# Notice of Allowability

10/799,675

RAO ET AL.

### **DETAILED ACTION**

FIG. 5

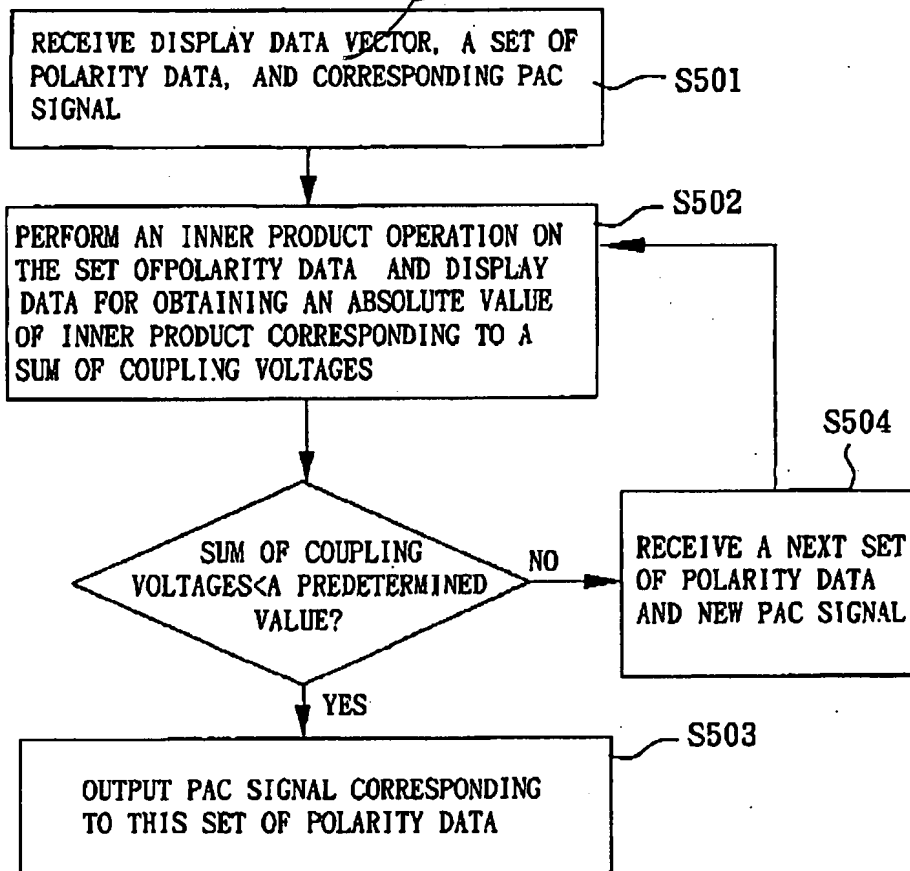
2. The drawings are objected to because typo or clerical errors for the claimed terms found in the Replacement Sheets for Figs. 5 and 8 submitted on June 13, 2007 as follows:

In Fig. 5, step S501: "DISPLAY DATA VECTOR" must be changed to --DISPLAY DATA--;

FIG. 8

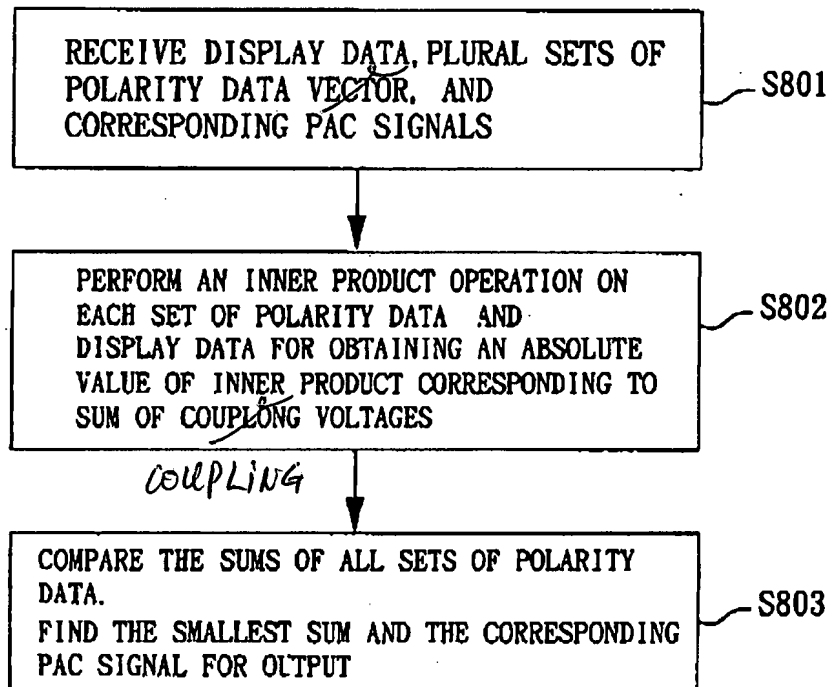
In Fig. 8, Step S801: "POLARITY DATA VECTOR" must be changed to --POLARITY DATA--; and in step S802: "COUPLONG VOLTAGE" must be changed to --COUPLING VOLTAGES--, see that attached Figs, 5 and 8. This is needed in order to avoid unnecessary correction after the issue of the letter of U.S. patent.
